Well Name: HUERFANITO UNIT Well Location: T26N / R9W / SEC 2 /

Well Number: 76E Type of Well: CONVENTIONAL GAS

Subsequent Report

Subject: [EXTERNAL] P&A Revision Request for Hilcorp's HUERFANITO UNIT 76E (API # 3004532978)

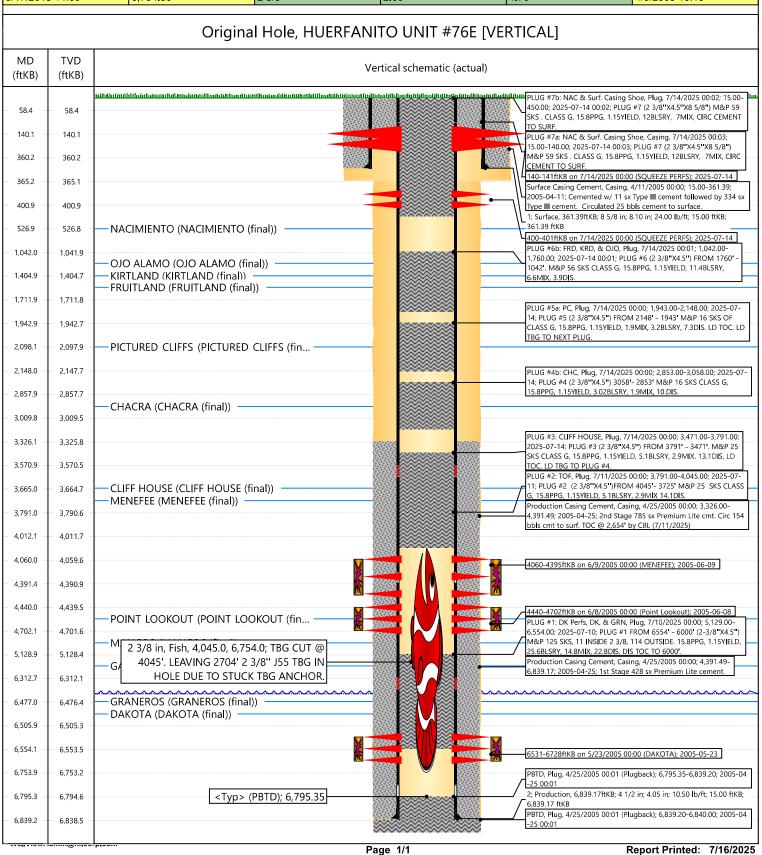
Based on the COAs, Hilcorp requests the following adjustments to the approved procedure:

- The NMOCD provided verbal approval to Hilcorp to forego separating out the Mancos plug as stated in the COAs of the approved NOI proceed with original plan of setting a 4-1/2" CICR @ 4,010' and pumping cement below the CICR to cover the Mancos formation. Plug #3 is designed as follows:

- PLUG #3: 110sx of Class G Cement (15.8 PPG, 1.15 yield); MCS Top @ 4,780' | DV Tool #1 Top @ 4,388'
 MV Perfs @ 4,060' | MV Top @ 3,665':
 - Set a 4-1/2" CICR @ 4,010'. Establish injection below the CICR.

- Pump 75sx of cement beneath the 4-1/2" CICR (est. TOC @ +/- 4,010' & est. BOC @ +/- 4,970').
 (~190' below the Mancos formation top @ 4780' per the NMOCD's excess cement request as verbally approved by the NMOCD).

- Sting out of CICR, pump a 35 sack balanced cement plug on top of the CICR. (est. TOC @ +/-3,565' & est. BOC @ +/-4,010'). Wait on Cement for 4 hours, tag TOC w/ work string. *Note cement plug lengths & volumes account for excess.

- *NOTE* If an injection rate cannot be established below CICR @ 4,010', Hilcorp requests to forego pumping cement below CICR & proceed with only pumping the 35sx of cement on top of CICR.

NMOCD approves below
